ADDENDUM NO. FIVE

January 28, 2025

Hart Memorial Park Adventure Play Area

1650.7014-21

SP-1

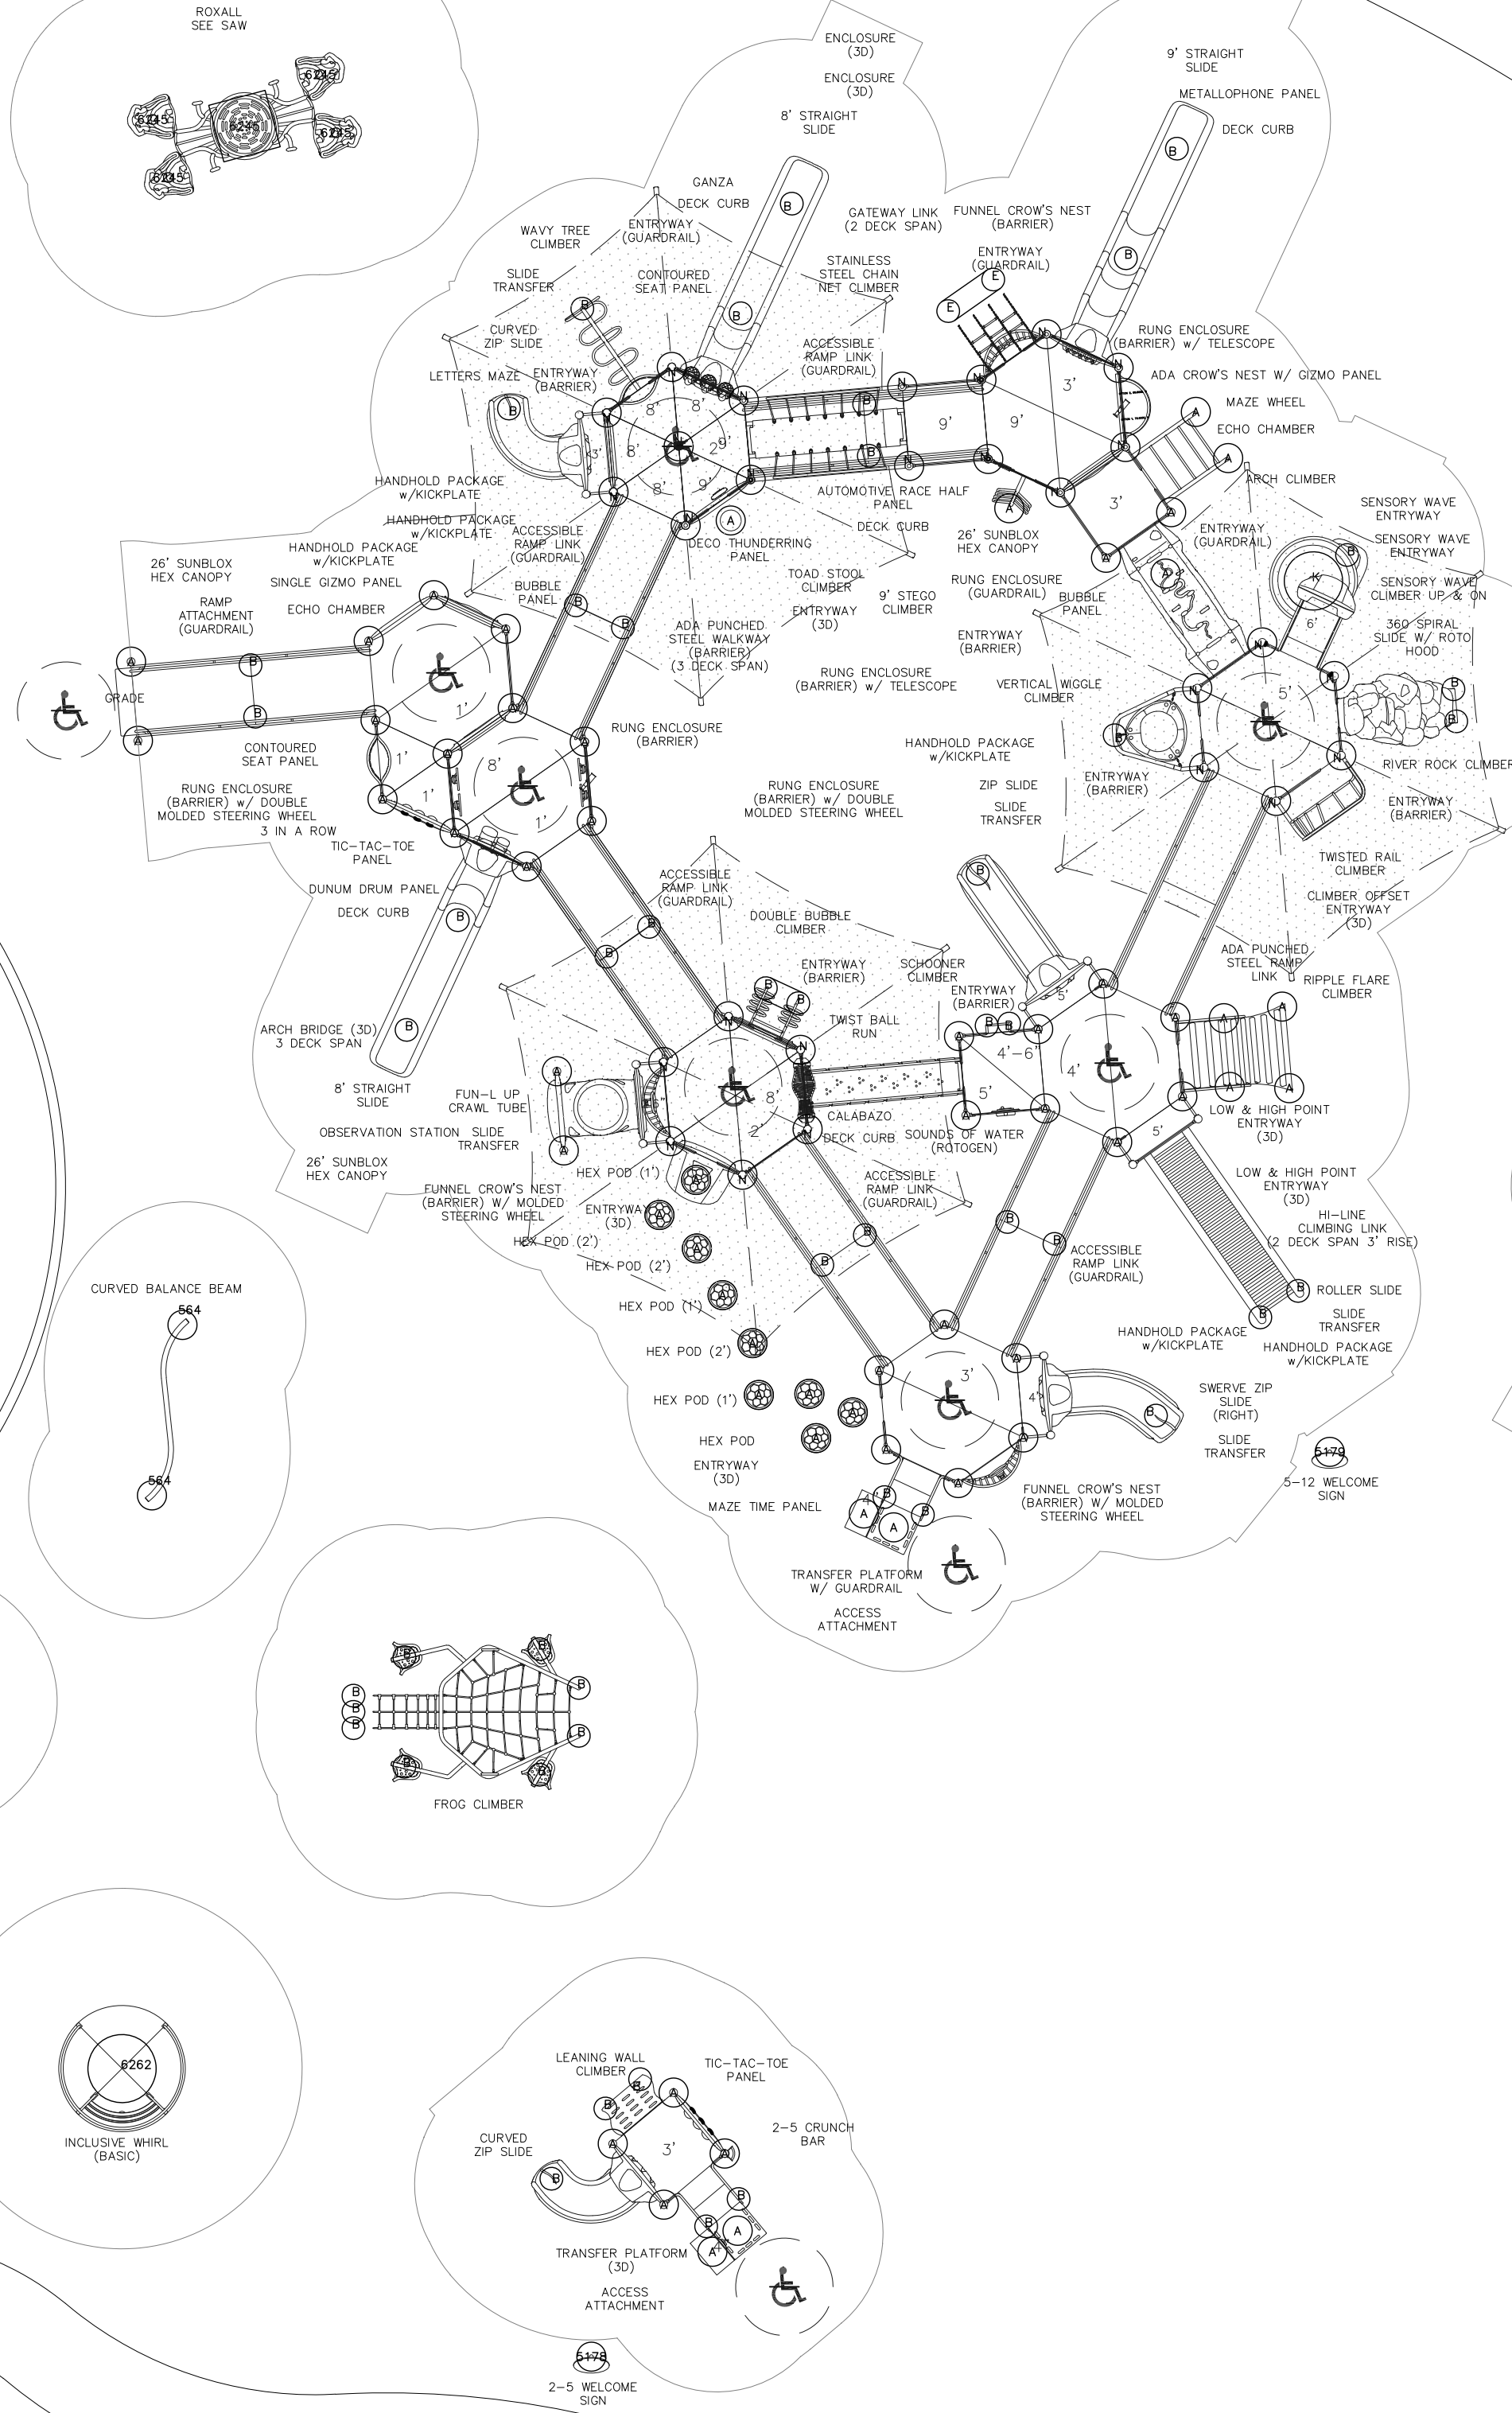
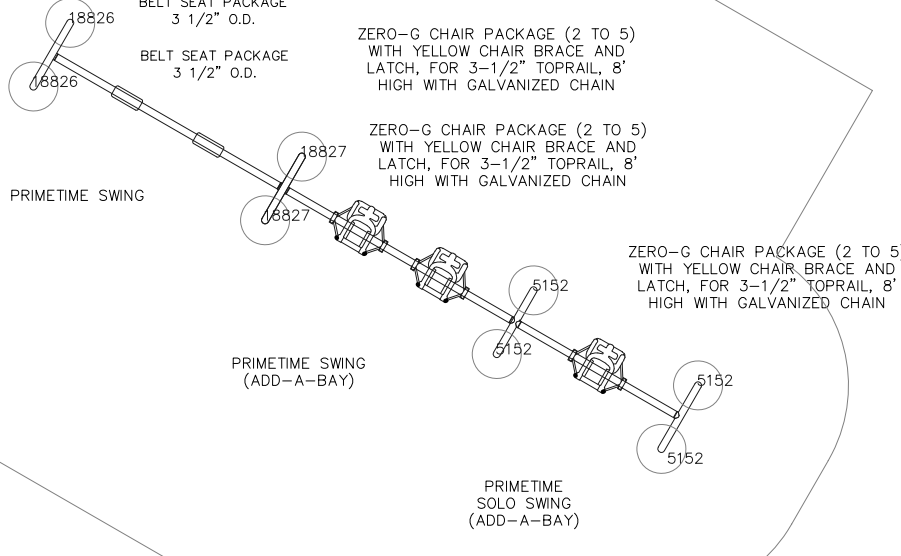
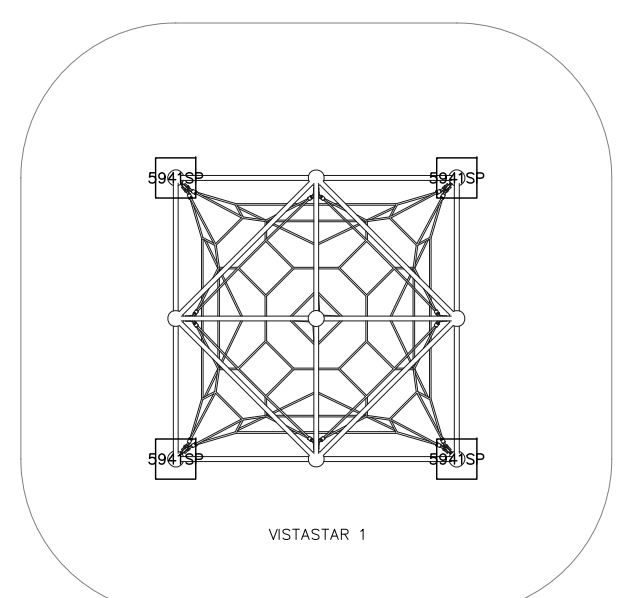
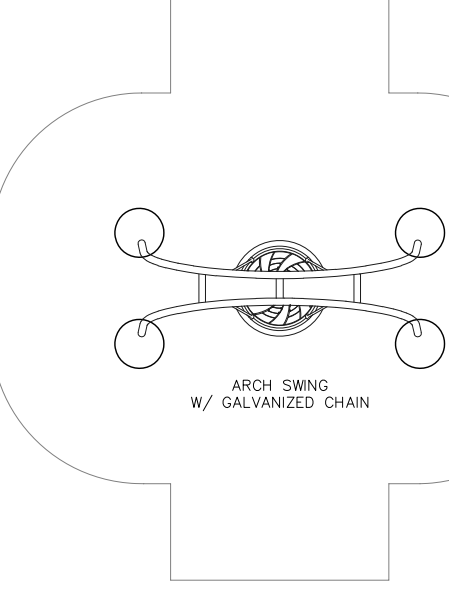
- Item No. 3:** Add attached site plan drawings SP-1, SP-2 and "Equipment list" document dated 1/28/2025. Drawings and document provide playground equipment and splash pad equipment part numbers, quantities, footing sizes, and locations.
